ADDENDUM NUMBER 1

Dated: October 10, 2023

Notice to Bidders, Contract, Proposal, Special Provisions and Plans for Construction of BROADWAY MAINTENANCE PROJECT CIP #42003

BROADWAY MAINTENANCE PROJECT CIP No. 42003

PROJECT NO. **6884.014**SHEET NO. **C14**OF **C36**

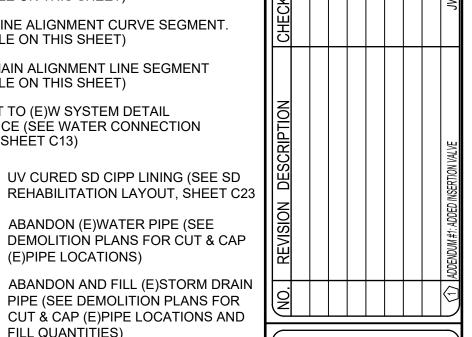
- Sheet C05: Revised pipe zone bedding material in detail 18. Pipe zone backfill shall be 3/4" Class II AB.
- Sheet C14*: Revised alignment of new water main and limits of steel casing pipe in Mosquito Road. Added a new water service replacement for property at southwest corner of the Mosquito & Broadway intersection (1144 Broadway).
- Sheet C18*: Revised 10" gate valve at Sta. 40+38 to be an insertion valve.
- Sheet C19*: Revised alignment of new water main and limits of steel casing pipe in Mosquito Road.

ADDENDUM#1: REVISED WATER ALIGNMENT & ADDED SERVICE

- 1) 37+92.36 (29.5' R) REPLACE WATER SERVICE LINE
- 2) 38+48.97 (27.7' R)
 REPLACE WATER SERVICE LINE AND REMOVE AND RELOCATE WATER METER
- 3 38+90.20 (27.6' R) REPLACE WATER SERVICE LINE AND REMOVE AND RELOCATE WATER METER
- 1 4 40+38.67 (0.63' L) INSTALL 10" INSERTION VALVE TO BE INSTALLED PER MANUFACTURER'S SPECIFICATIONS.
- (5) <u>39+77.27 (16.5' L)</u> CONNECT TO (E)SDMH (SEE PROFILE FOR RIM & INV ELEVATIONS) • 36"(NE) INV IN: INSTALL MANHOLE PLUG PER DETAIL 19, SHEET C05
- 6 39+92.82 (8.5' L) CONNECT TO (E)SDMH (SEE PROFILE FOR RIM & INV ELEVATIONS)
- 7 40+55.77 (8.1' L) 60" SDMH PER DETAIL 17, SHEET C05 (SEE PROFILE FOR RIM & INV ELEVATIONS)

6884.014 SHEET NO. C23 OF C36

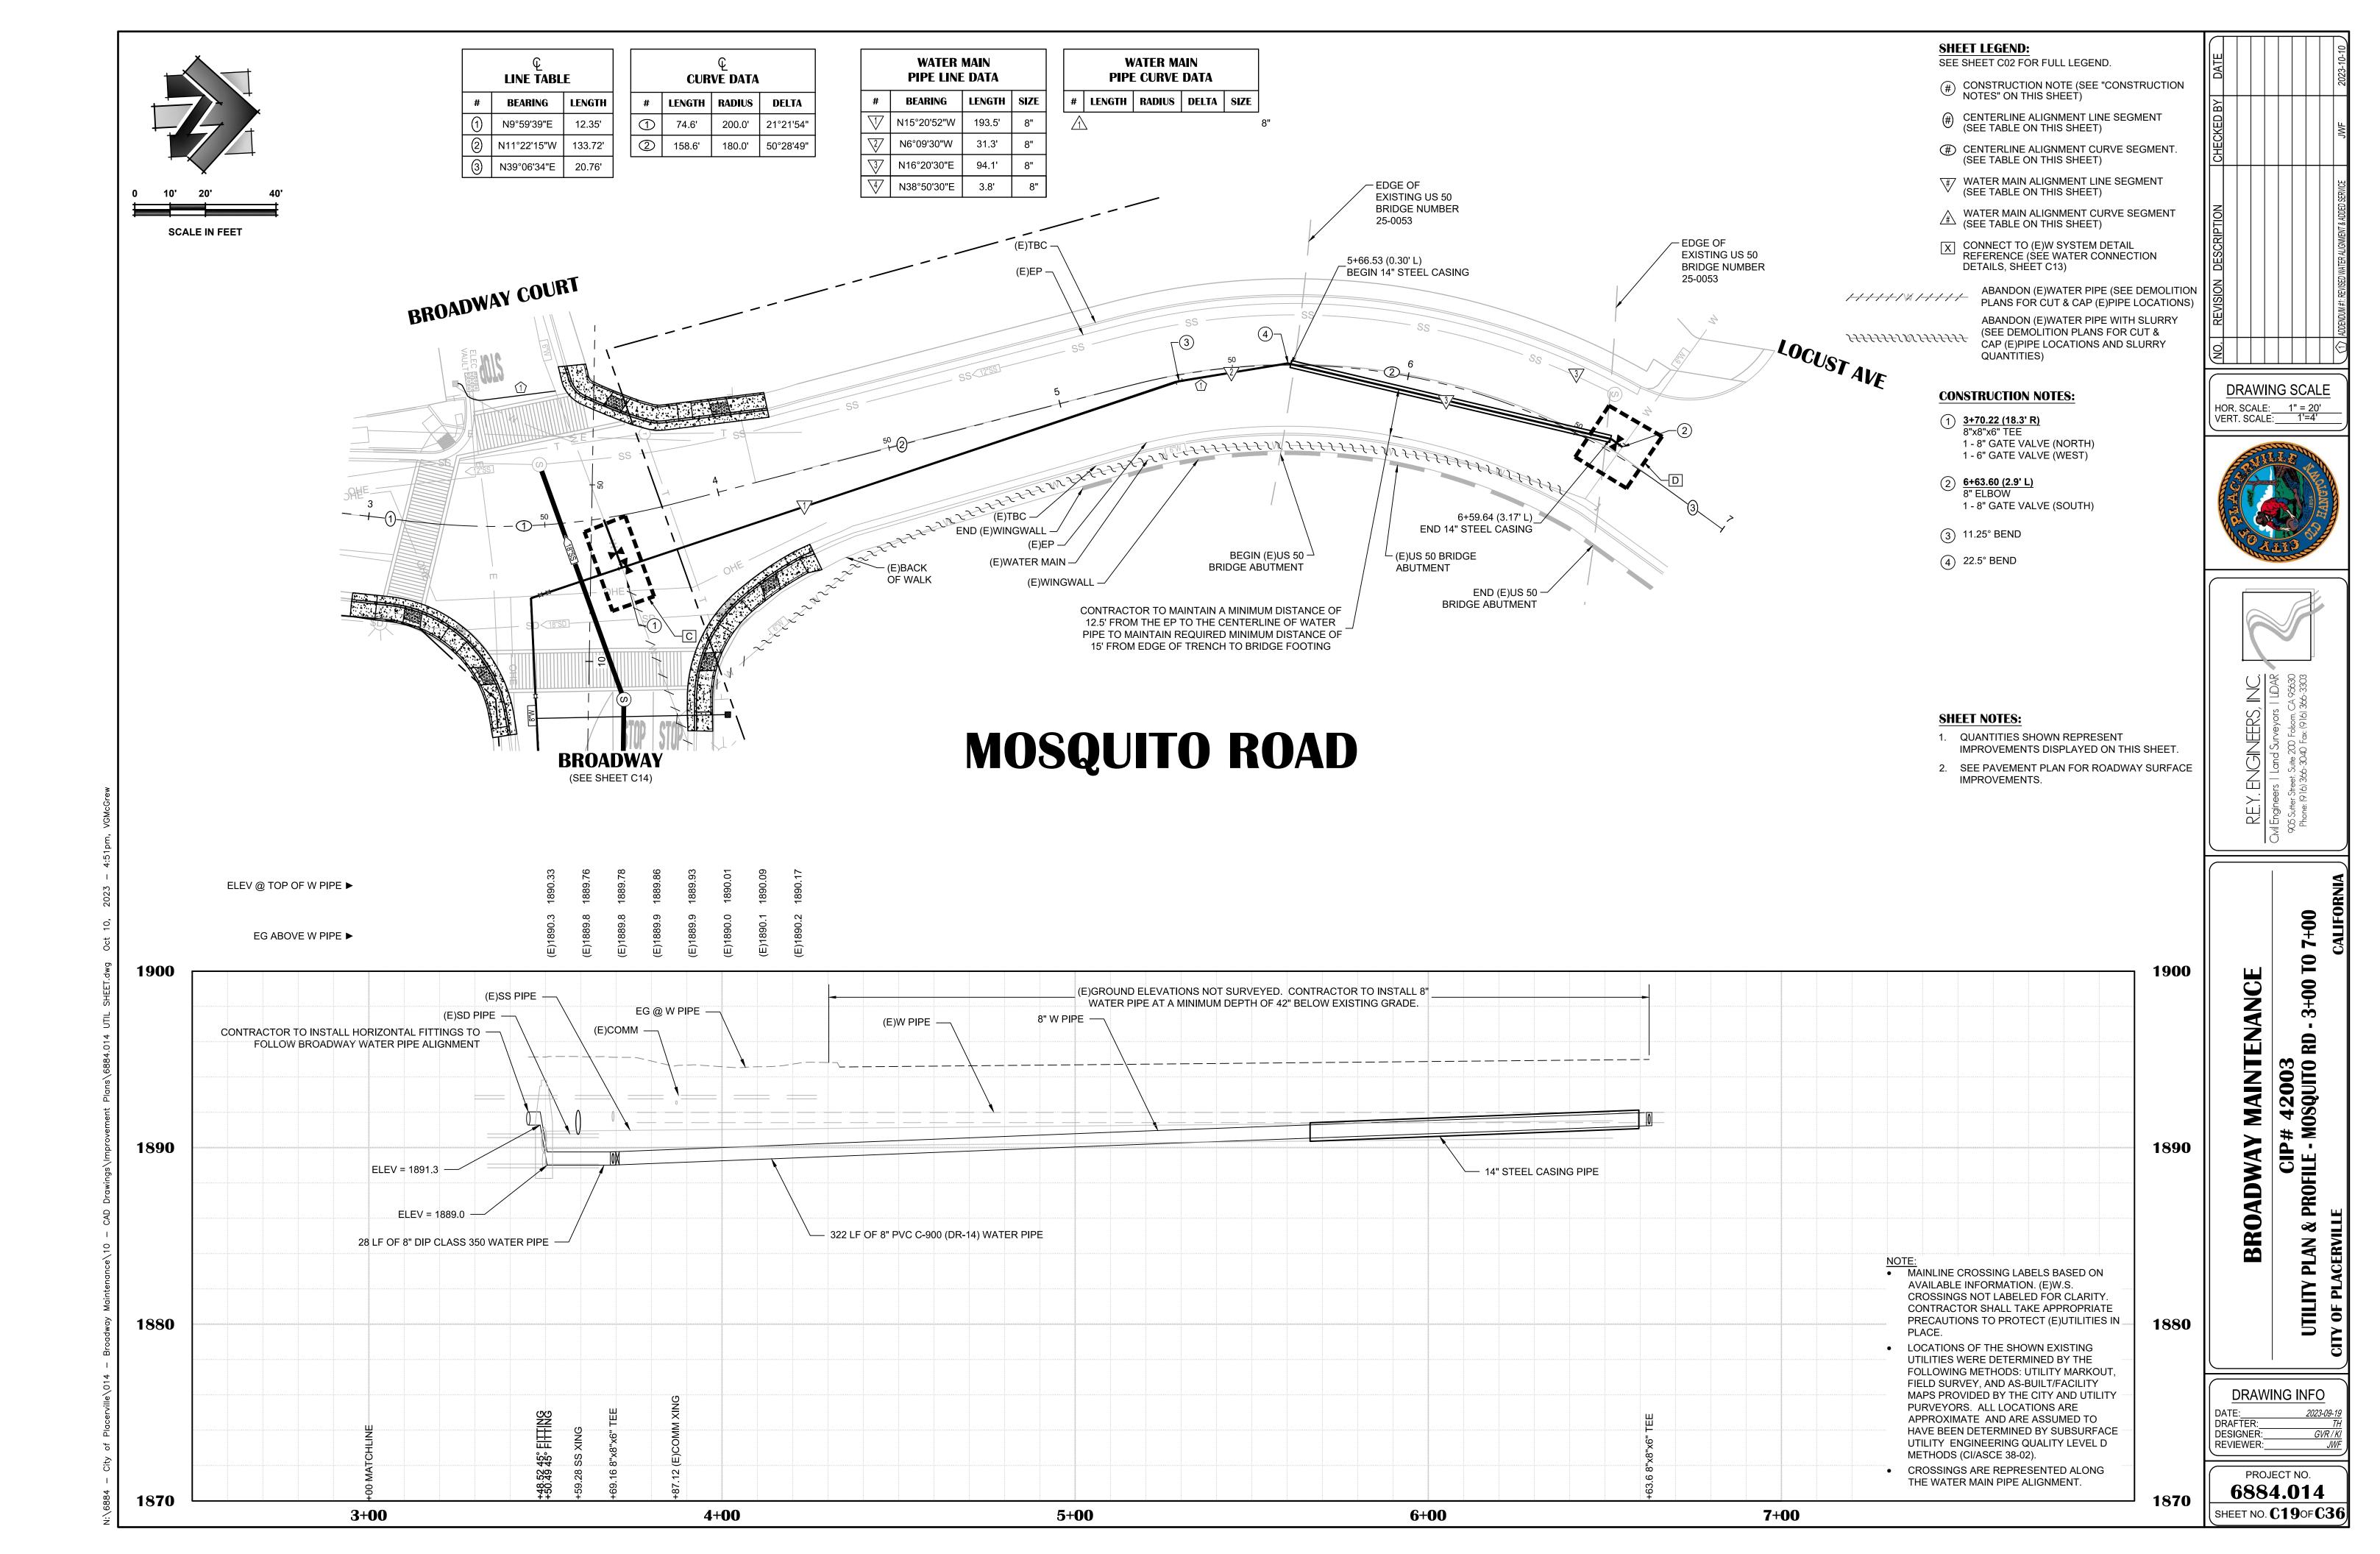
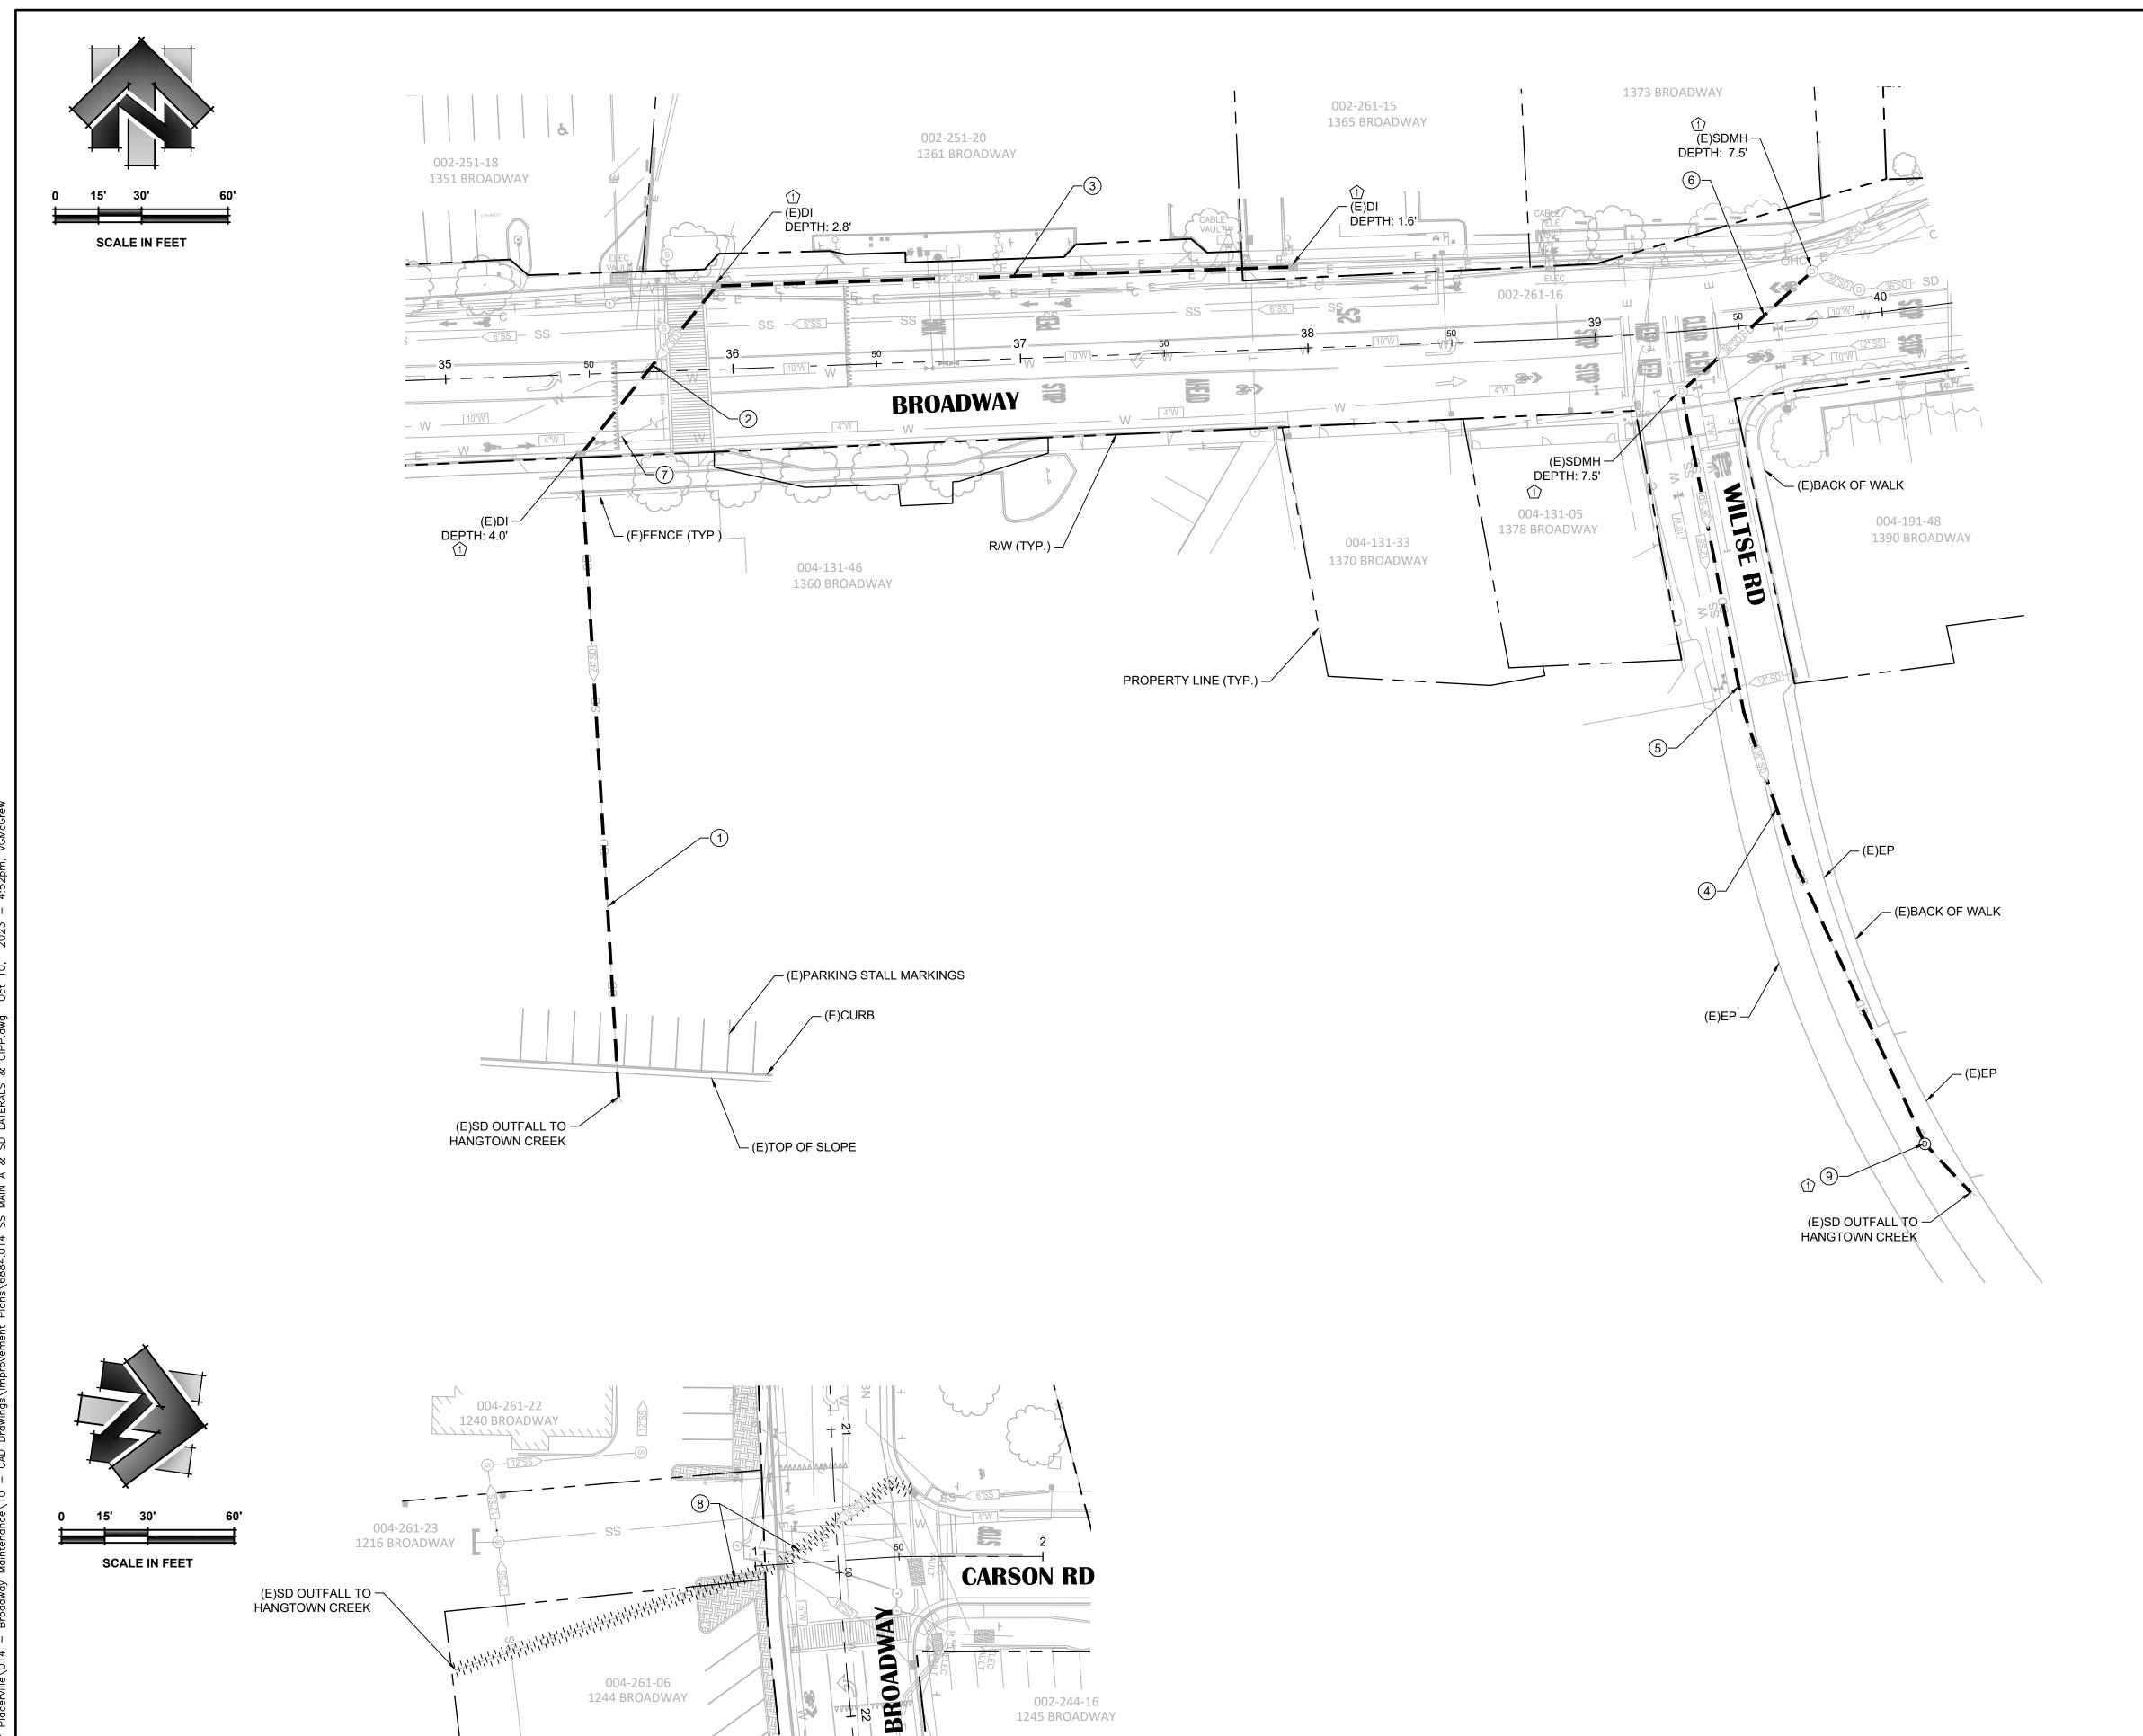
Question 2: After review of the outfall of the 36" UV CIPP Liner, it appears outfall is towards the middle of the culvert. A 36" UV liner is very heavy and has to be pulled in, due to the location of the outfall this is going to make the install extremely difficult with the weight of the liner and the bends that would need to be negotiated for install. Can a

manhole be added to the project and placed just before the bridge and the last portion of the 36" Liner be made into two segments?

Question 3: Can you provide depths of the Manholes for the UV CIPP Liner?

Sheet C23*: Added depths to the existing storm drain manholes and inlets in the systems receiving UV Cured SD CIPP Lining. Added 60" storm drain manhole to this stretch of storm drain to facilitate installation of liner.

<u>City's response to Question 2:</u> A manhole has been added to the plans on revised sheet C23.

<u>City's response to Question 3:</u> Refer to plan sheet revisions for sheet C23, below and attached, for manhole and inlet depths.

- 3 200.6 LF OF 12" UV CURED SD CIPP LINING (FROM (E)DI TO (E)DI).
- 4 GROUT EXISTING SD FLOWLINE. INSTALL 299.7 LF OF 36" UV CURED SD CIPP LINING (FROM (E)MANHOLE TO (E)SD OUTFALL).

- (5) RESTORE 12" BLIND SD LATERAL CONNECTION AFTER 36" CIPP LINING OF THE SD MAIN IS COMPLETED.
- (6) GROUT EXISTING SD FLOWLINE. 61.7 LF OF 36" UV CURED SD CIPP LINING FROM (E)MANHOLE TO (E)MANHOLE.

- 8 CLEAN & FLUSH (E)SD PIPE (178 LF)
- ① 9 60" SDMH PER DETAIL 17, SHEET C05. RIM ELEVATION TO MATCH EXISTING GROUND.
